RE: Windfall Oil & Gas, Inc.
Permit # PAS2D020BCLE
PERMITTED FACILITY: Class II-D injection well, Zelman #1

UIC Permit No. PAS2D020BCLE

Zelman #1 Class II-D injection well

PETITION FOR REVIEW

DEP Well Plat

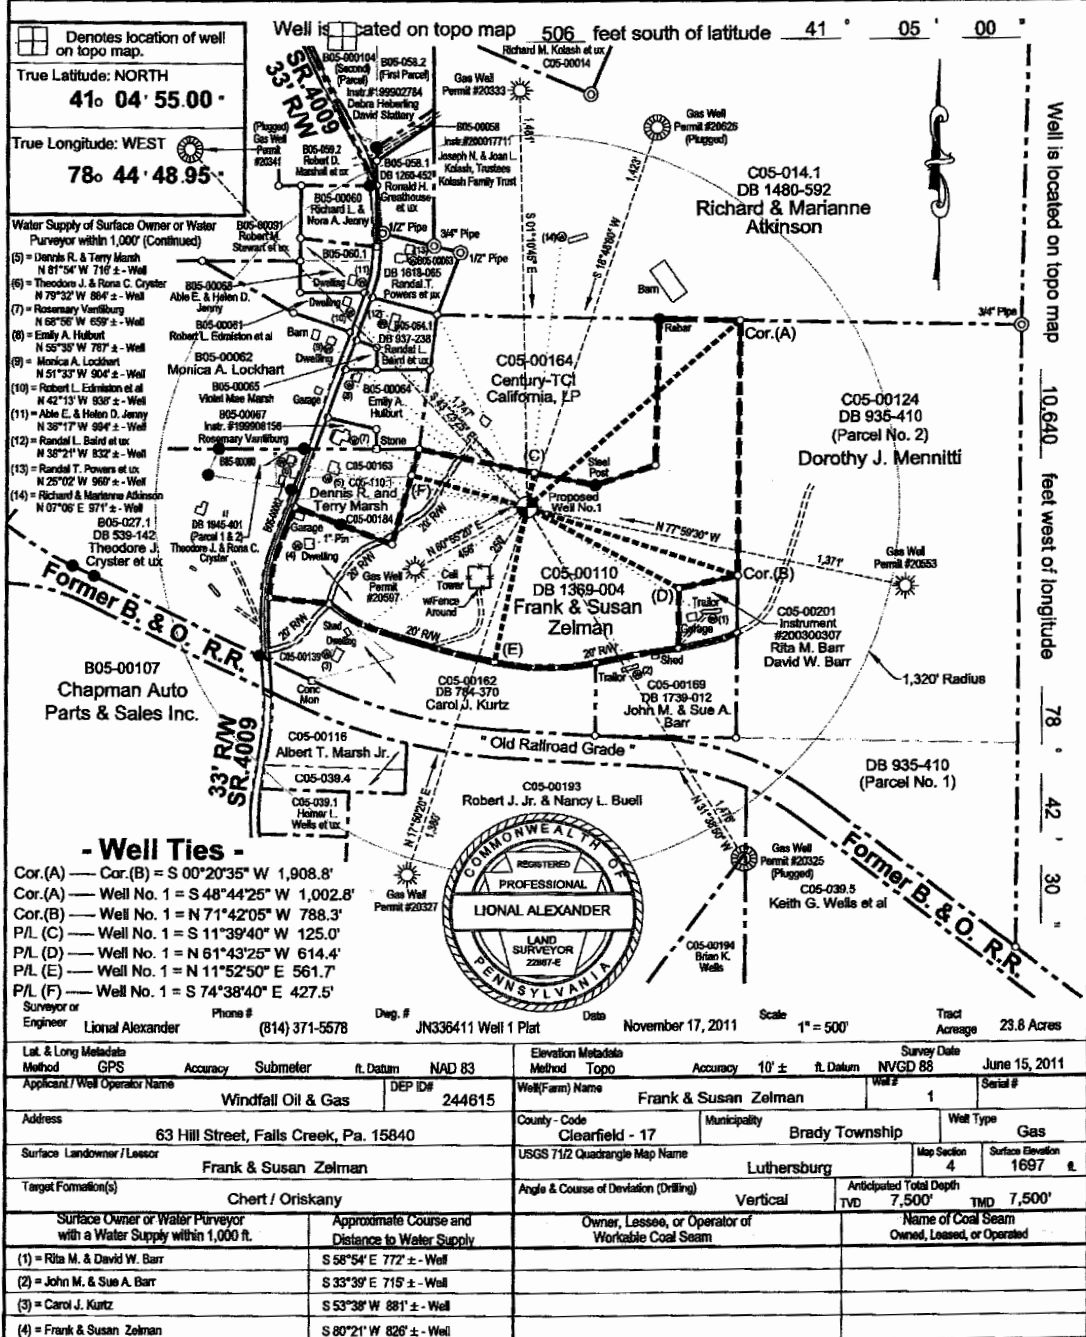
There are 2 deep conventional gas wells that are JUST outside the Area of Review, which go into the Oriskany formation, which is **also** the injection formation. Both of these deep gas wells have been fracked. They can be seen on the DEP Well Plat map on page 7.

The Potter #2, #033-20327 gas well goes into the Oriskany Sandstone and was fracked on Sept 27, 1960 and is 60 feet outside Area of Review to the **south**. See gas well records on pages 12-15.

The Ginter/DuBois Deposit Bank #033-20333 gas well goes into the Oriskany Sandstone and was fracked on December 22, 1960 and is 161 feet outside Area of Review to the **north**. See gas well records on pages 16-19.

These fractures could extend significantly more than 60 feet or even 161 feet to extend into the Area of Review. If the fractures extend 750+ feet as the NETL study indicates, they would extend well into the Area of Review. The fractures could then provide a conduit for toxic injected fluids to migrate upwards into a USDW.

These fractures could also result in the actual Zone of Endangering Influence (ZEI) being extended beyond the ¼ mile radius Area of Review.

COMMONWEALTH OF PENNSYLVANIA
DEPARTMENT OF ENVIRONMENTAL PROTECTION
Oil and Gas Management Program
WELL LOCATION PLAT

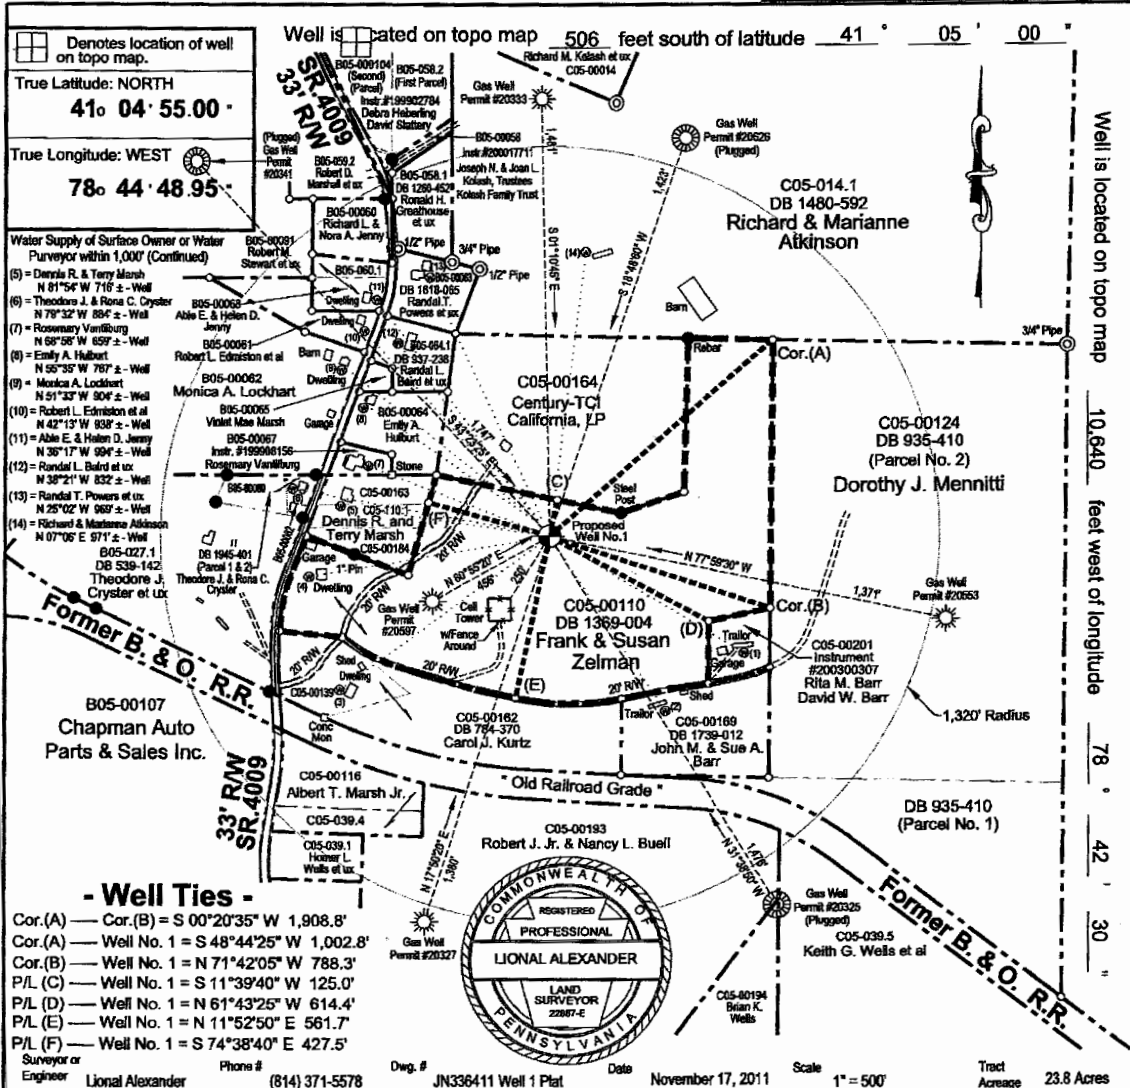
From the DEP Well Plat map on page 22, that was submitted to the EPA by Windfall with their UIC permit application, it can be seen that gas well #37-033-30327 is **1380 feet south/southwest away** from the proposed injection well. This is **60 feet outside the ¼ mile (1320 feet) radius Area of Review.**

From the DEP Well Plat map submitted to the EPA by Windfall with their UIC permit application, it can be seen that gas well #37-033-20333 is **1481 feet north away** from the proposed injection well. This is **161 feet outside the ¼ mile (1320 feet) radius Area of Review.**

Neither of these gas wells is one-half mile (**2640 feet**) to a mile (**5280 feet**) from the proposed disposal injection well location, which is an error in the Response to Comments, #12 on page 13.

The EPA made a mistake when they called gas well #37-033-30327 the Zelman well, when it is really named the Potter #2 well. See cover page of well record on page 23 for Potter #2 - #37-033-30327.

Response to Comments #13, page 15:

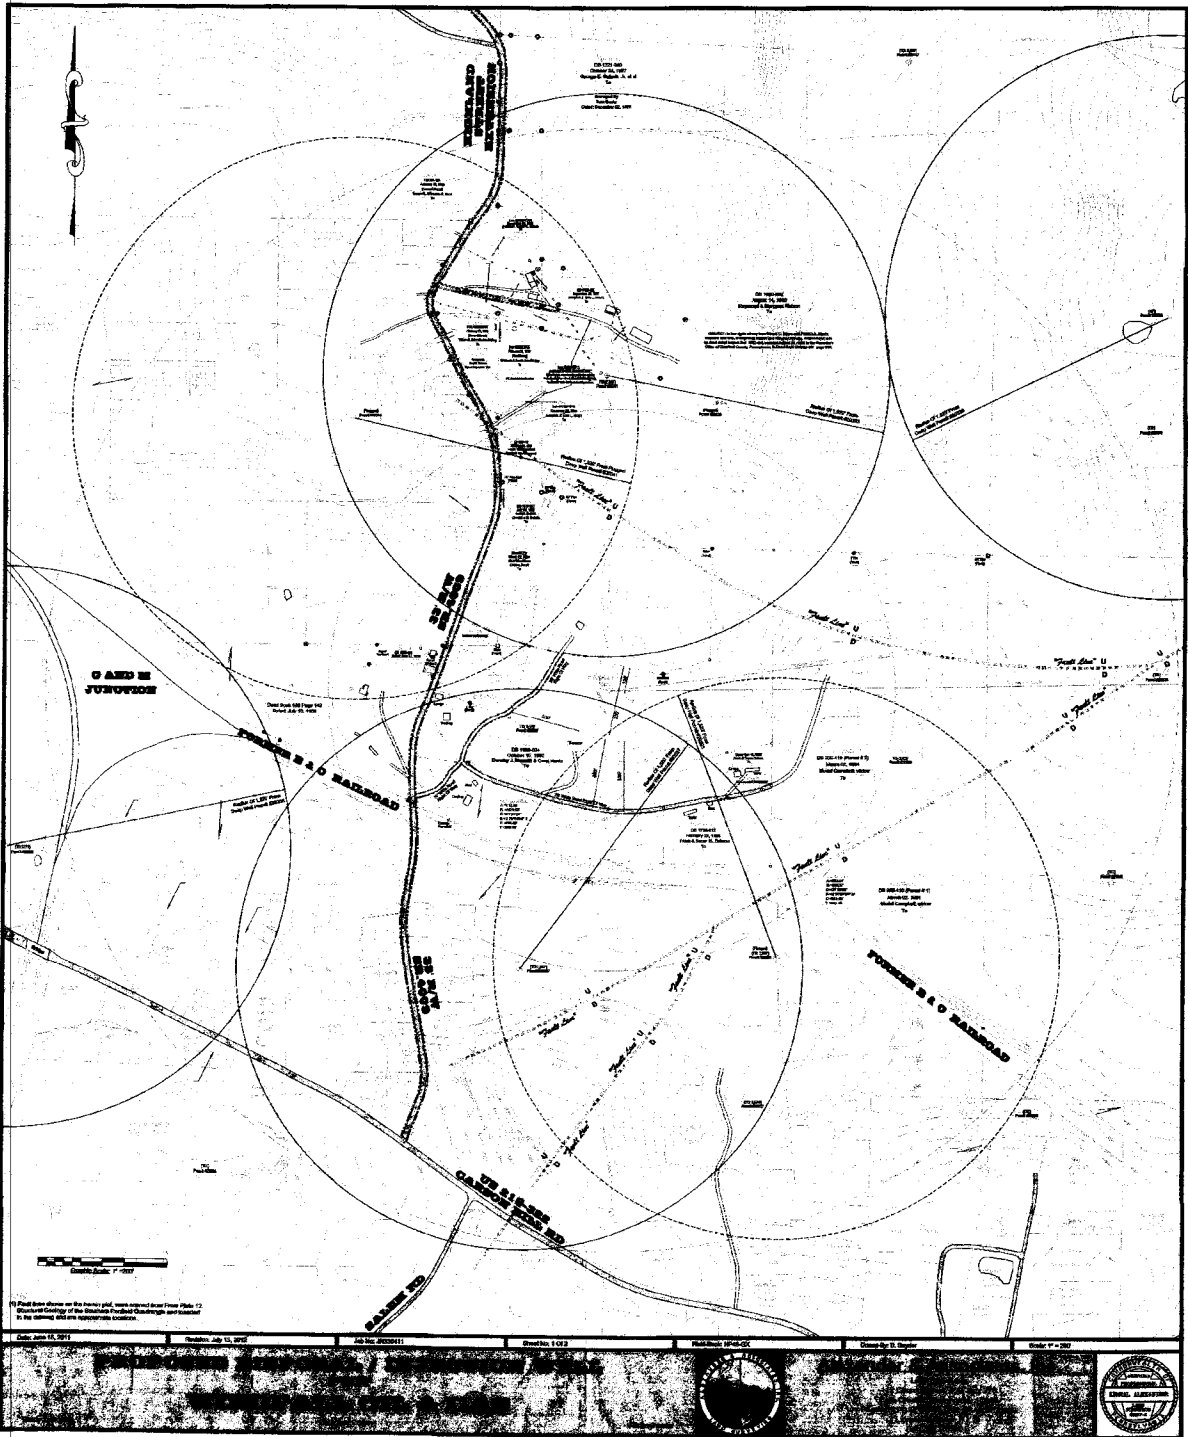
Several commenters challenge the use of the ZEI calculation for this site because the model assumes that the injection zone is homogeneous and isotropic, with an infinite areal extent. The modified Theis equation EPA used to calculate the ZEI does assume that the injection zone is homogeneous and isotropic and has infinite areal extent, which may not be the case in an area of review with a nontransmissive fault. However, even though EPA did calculate a ZEI, EPA used an area of review for this well based on a fixed radius of one-quarter mile rather than the radius determined by the ZEI calculation. When EPA compared the radius resulting from the ZEI calculation to that of the one-quarter mile fixed radius, the ZEI radius was at least three times smaller than the fixed radius, resulting in a ZEI area of review about a tenth of the size of the area of review based on a one-quarter mile fixed radius.

First, the EPA admits that the Windfall injection zone did not meet the conditions required for a modified Theis equation to calculate the ZEI. There are actually two non-transmissive faults in the vicinity of the proposed disposal injection well and they join together to form a "V" shape. This can be seen on the map on page 25.

The only place for the injected waste fluid to flow away from the proposed disposal injection well is through the open end of the "V". Therefore, any calculated ZEI would have to be larger than what the EPA calculated using a modified Theis equation. It is possible that a more accurately calculated ZEI would extend beyond the boundary of the ¼ mile radius Area of Review.

A more accurate ZEI calculation would have to be done using a computer model.

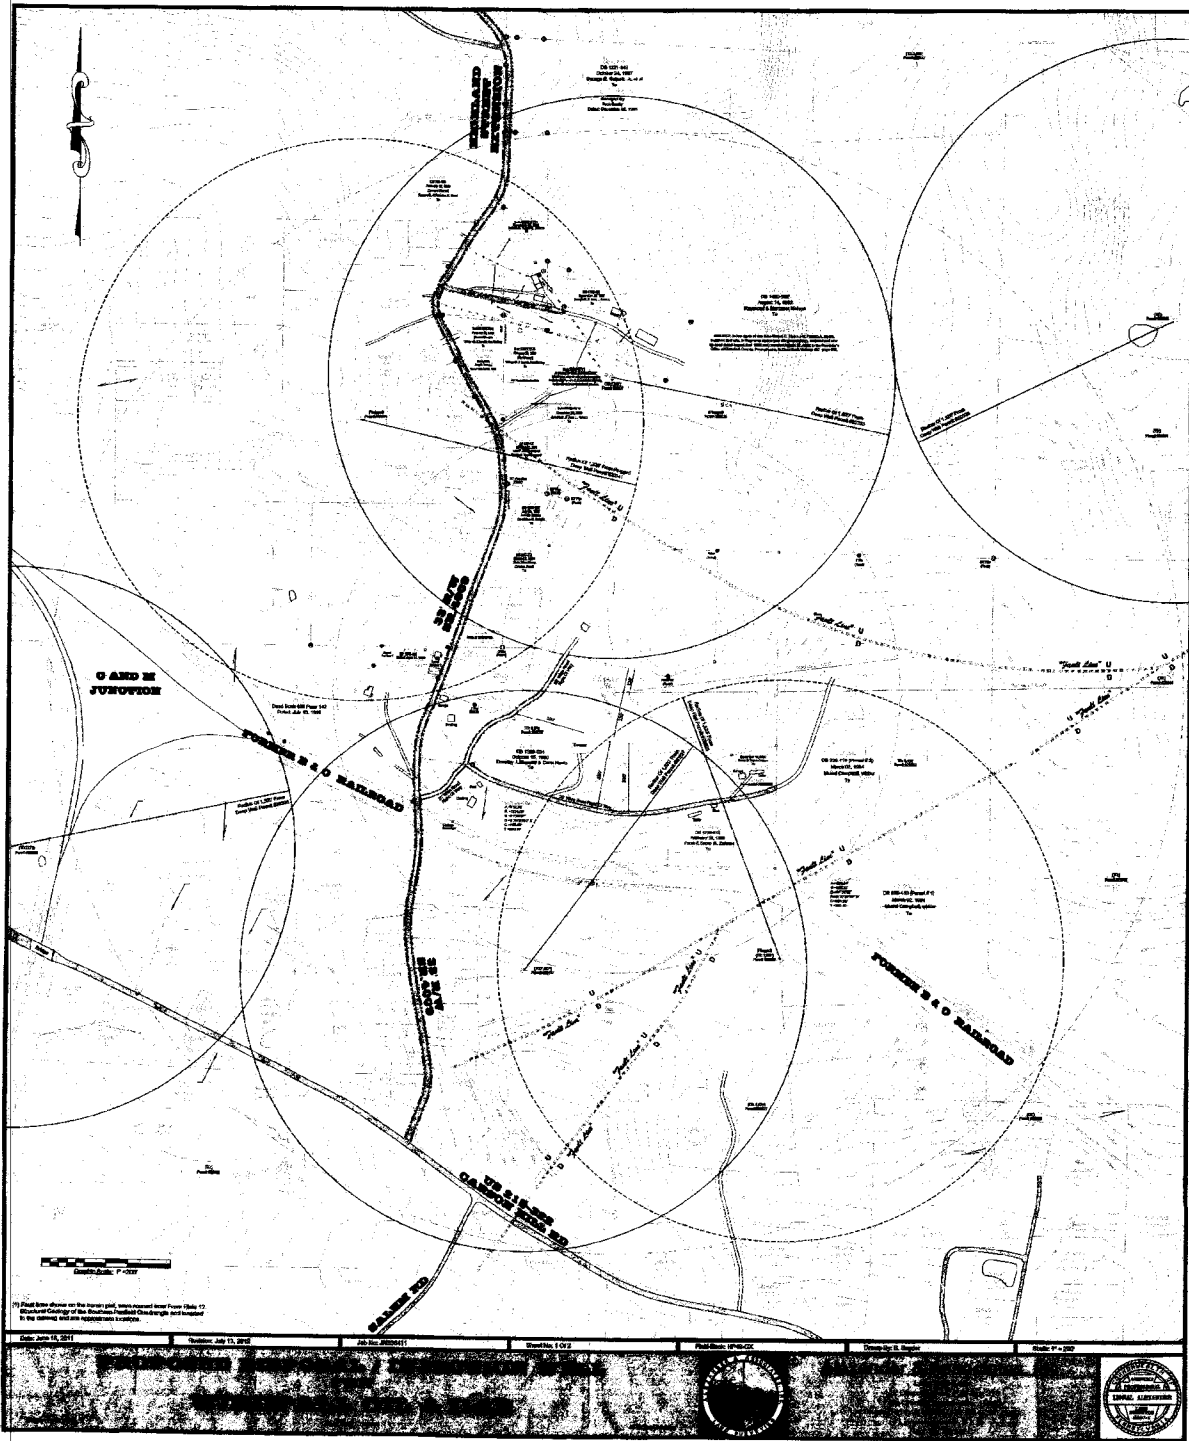
"For example, gas well #20333, located between the faults..."

This gas well is actually located outside of the faults. This is an error, as can be seen on the Alexander & Associates map that shows the faults on page 30.

Gas well #20333 is located just outside the Area of Review, 1381 feet to the north of the proposed disposal injection well.

DEP Well Plat

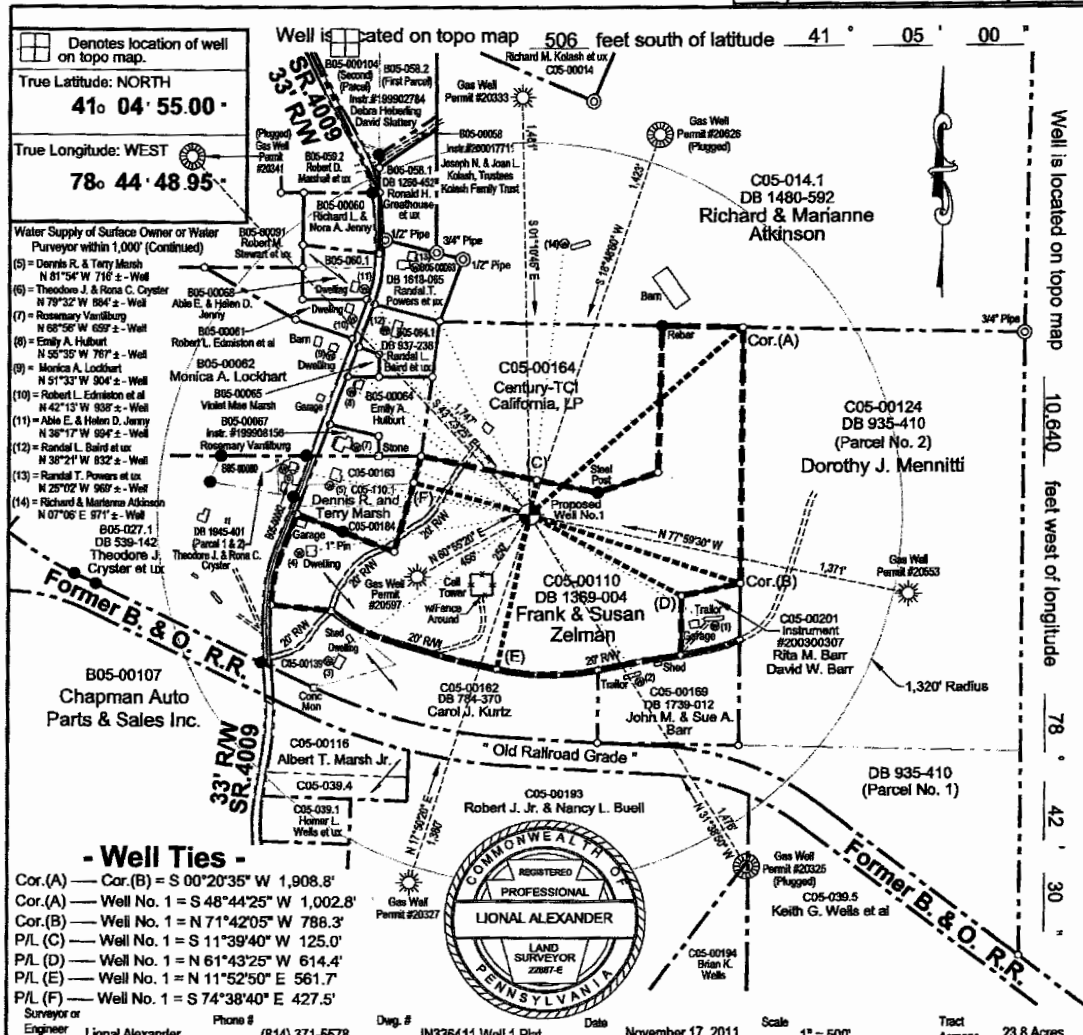
There are 2 deep conventional gas wells that are JUST outside the Area of Review, which go into the Oriskany formation, which is the disposal well injection formation. Both of these deep gas wells have been fracked. They can be seen on the DEP Well Plat on page 33.

The Potter #2, #033-20327 gas well goes into the Oriskany Sandstone and was fracked on Sept 27, 1960 and is 60 feet outside Area of Review to the **south**. See gas well records on pages 34-37.

The Ginter/DuBois Deposit Bank #033-20333 gas well goes into the Oriskany Sandstone and was fracked on December 22, 1960 and is 161 feet outside Area of Review to the **north**. See gas well records on pages 38-41.

If the fractures from these vertical gas wells extend 750+ feet as the NETL study indicates is possible, they would extend well into the Area of Review. The fractures could then provide a conduit for high pressured toxic injected fluids to migrate beyond the boundary of the ¼ mile radius Area of Review. .

Therefore, these fractures could also result in the actual Zone of Endangering Influence (ZEI) being extended beyond the ¼ mile radius Area of Review.
